THE GLEN AT WIDEFIELD FILING NO. 10

RESIDENTIAL SUBDIVISION CONSTRUCTION DRAWINGS

February 12, 2020
PCD File No. SF-1921

Raised Island Detail (Public ROW)
SCALE: 1"=20'

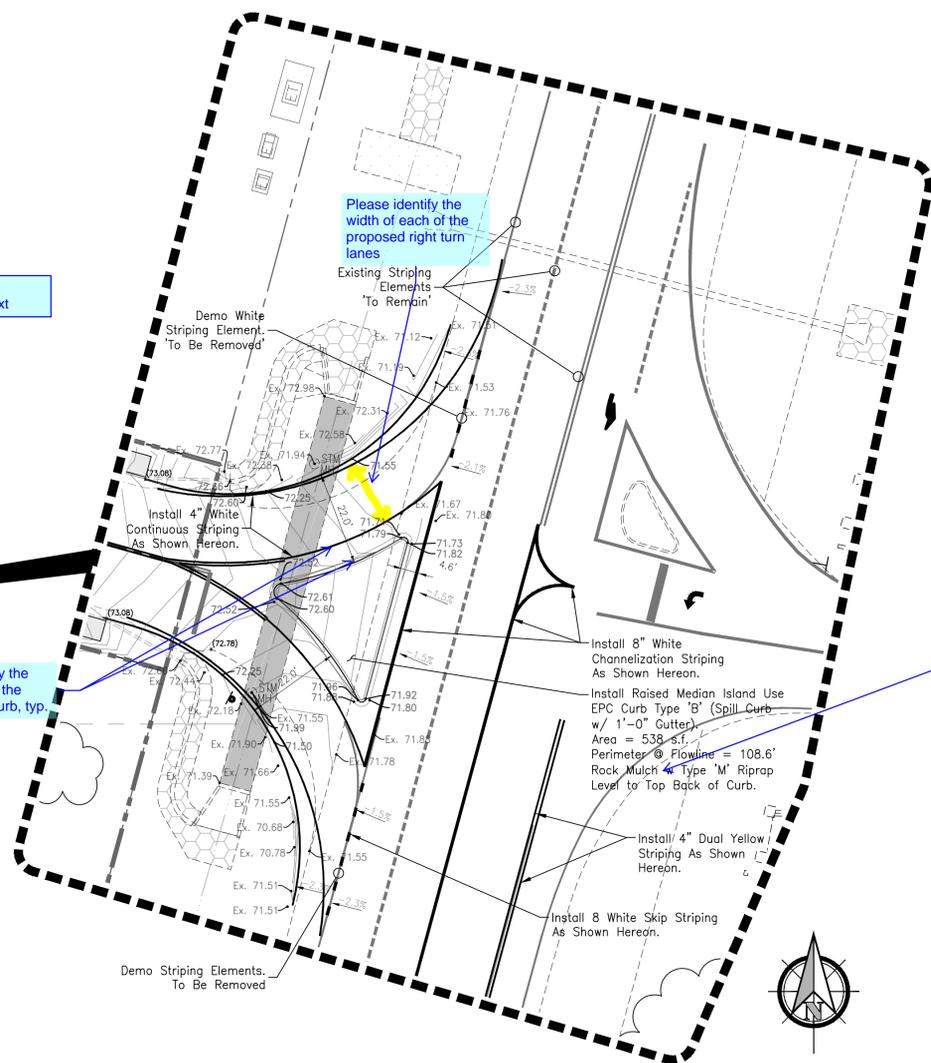
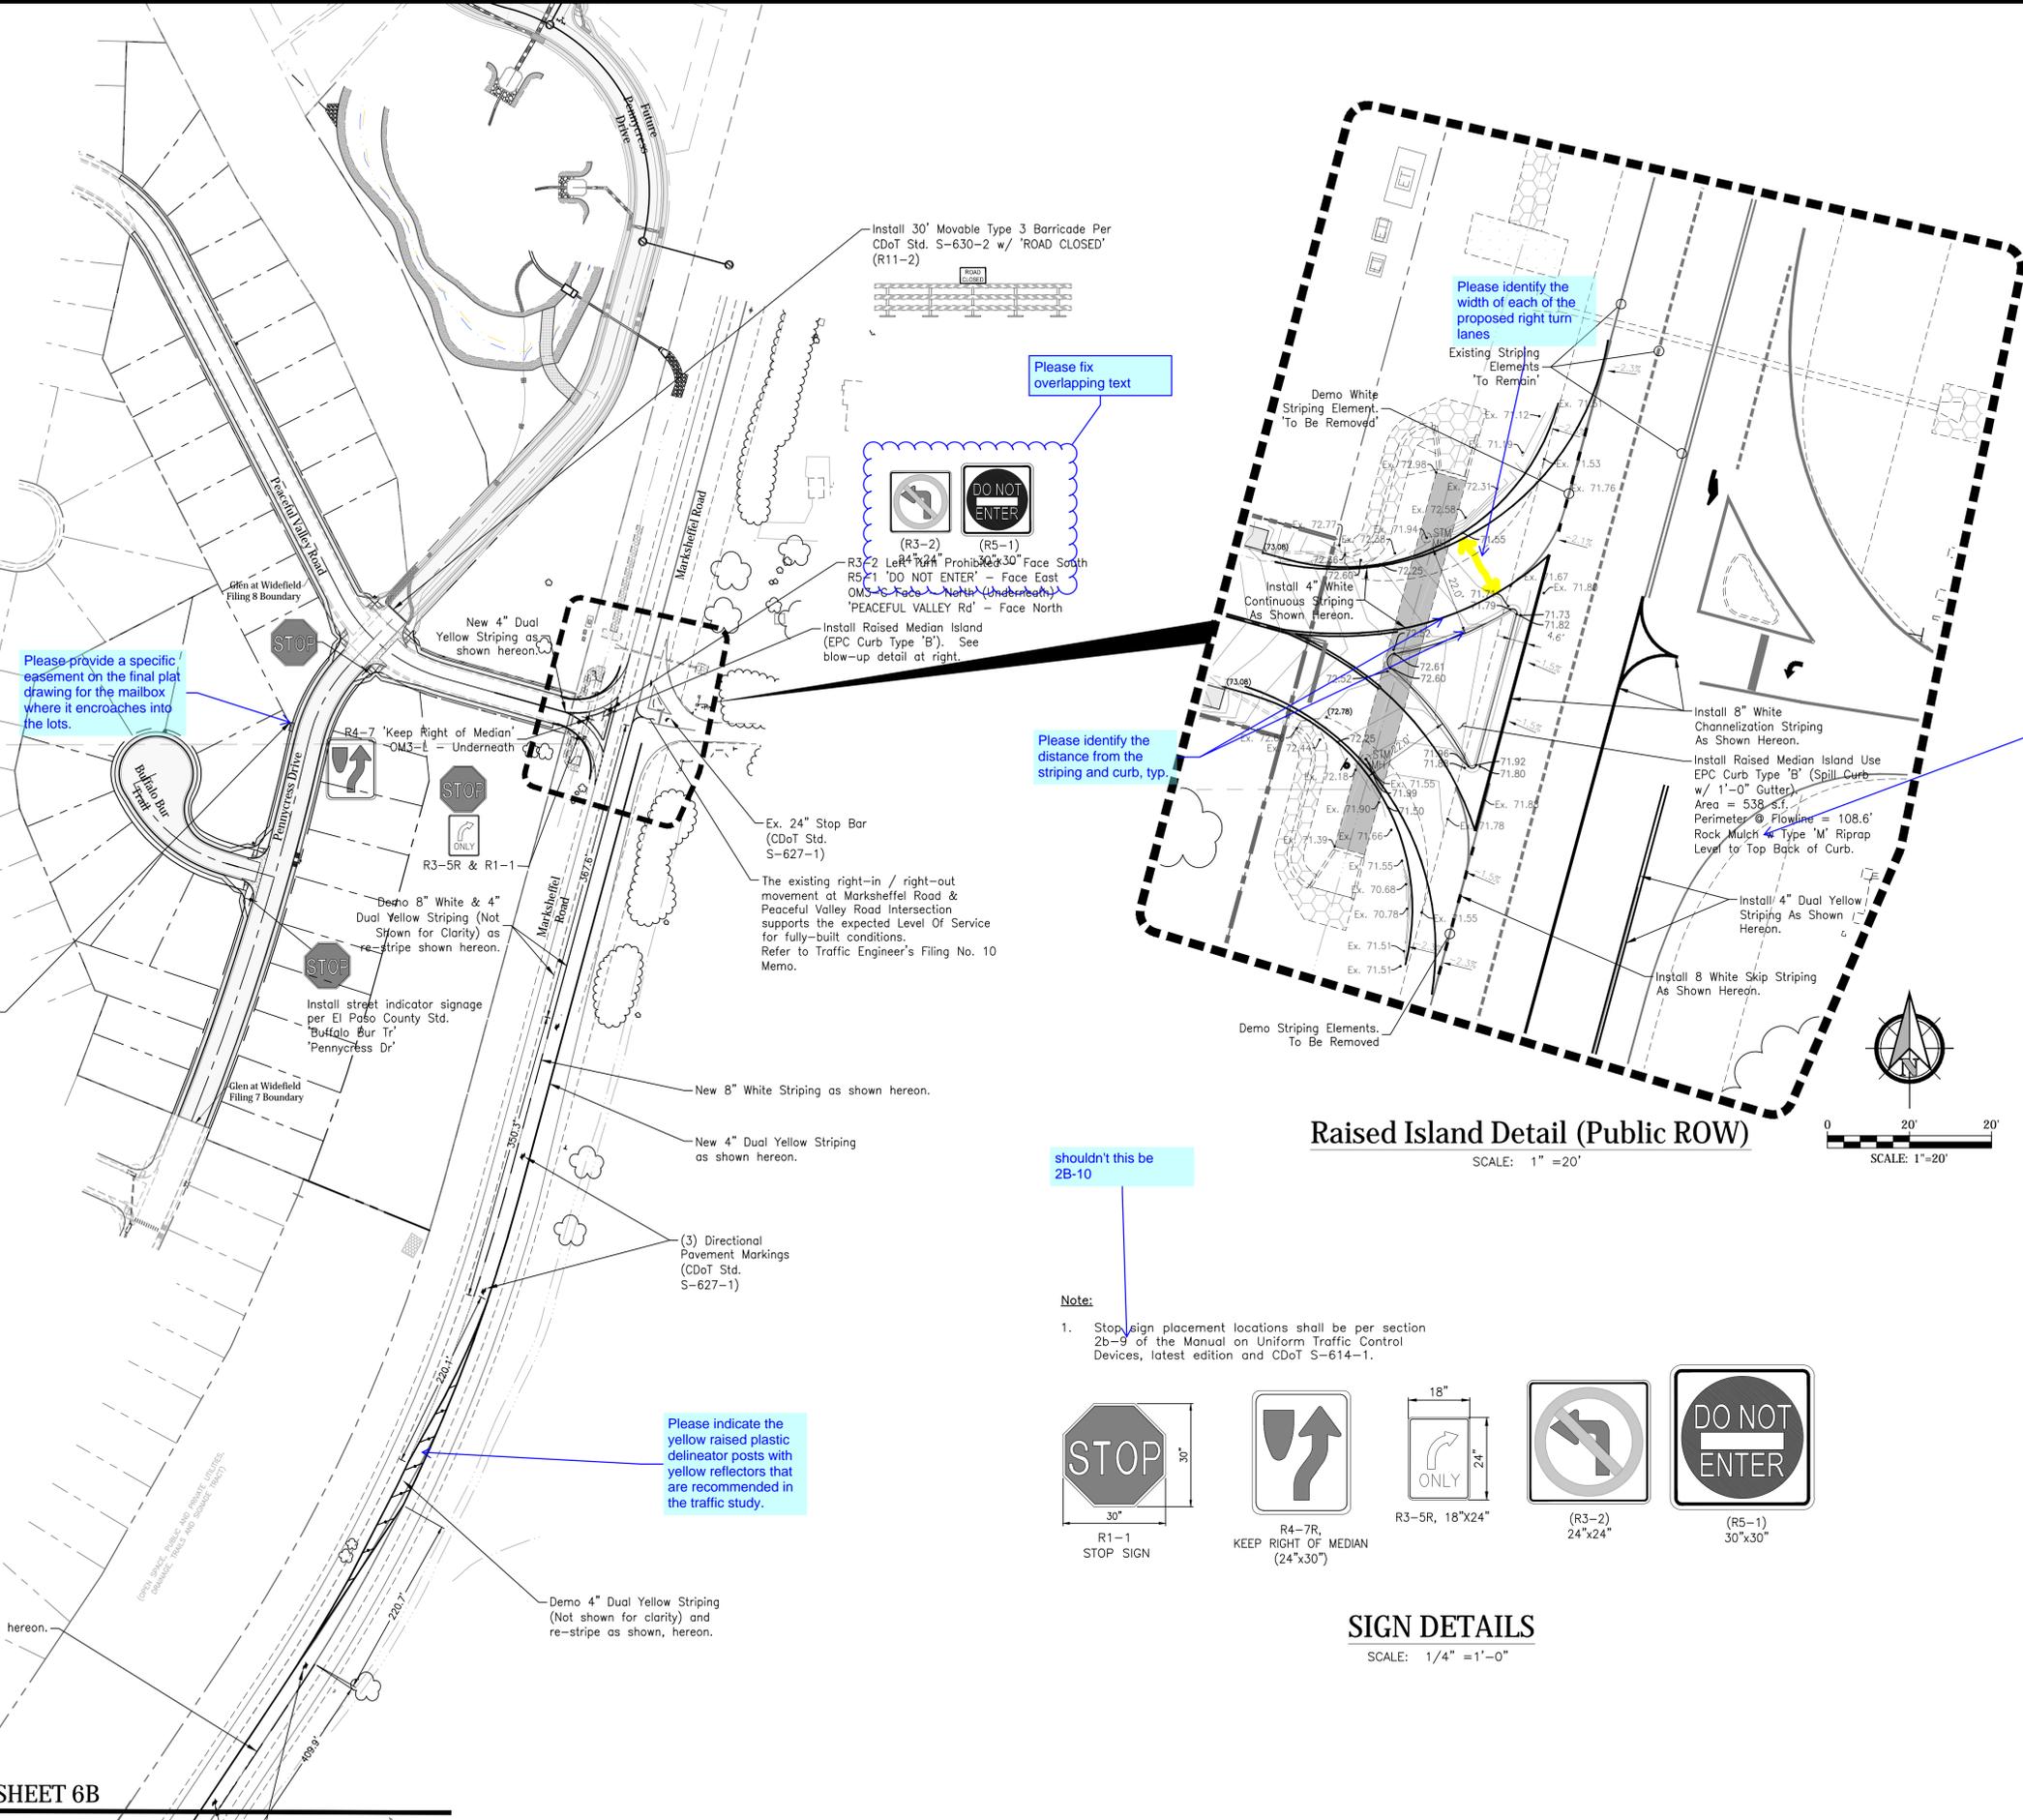
Per ECM 2.5.6 the median shall be paved with stamped concrete. Also refer to County standard detail SD_2-21

SIGN DETAILS
SCALE: 1/4"=1'-0"

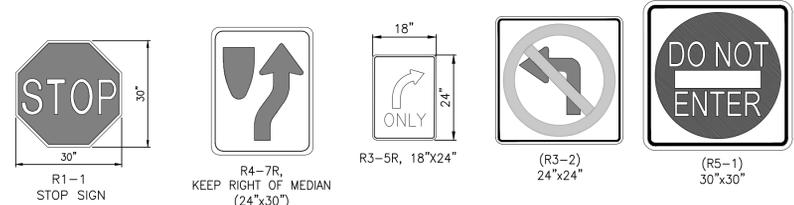
shouldn't this be 2B-10

K WQCV SCREENING PLATE
12 Scale: NTS

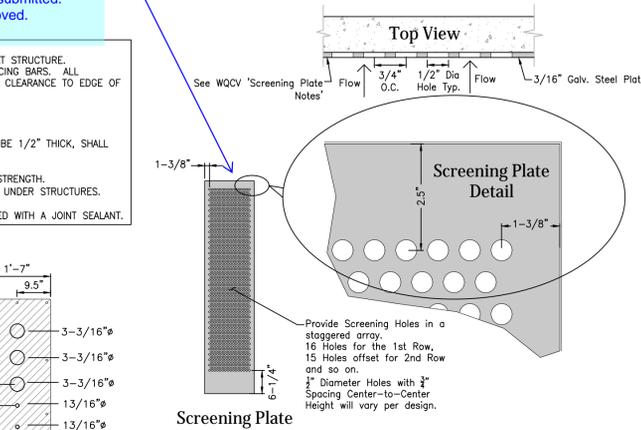
Review 3 comment: After discussion with staff, it was determined that the trash rack shall be a well screen (No.93 Johnson Vee wire) or bar grate (Amico Klomp SR series) as indicated in the recent ECM adopted (July 2019) outlet structure details from urban drainage. Any alternative would require a deviation request form to be submitted. Submittal of a deviation request form does not imply that it will be approved.
Review 5: Unresolved
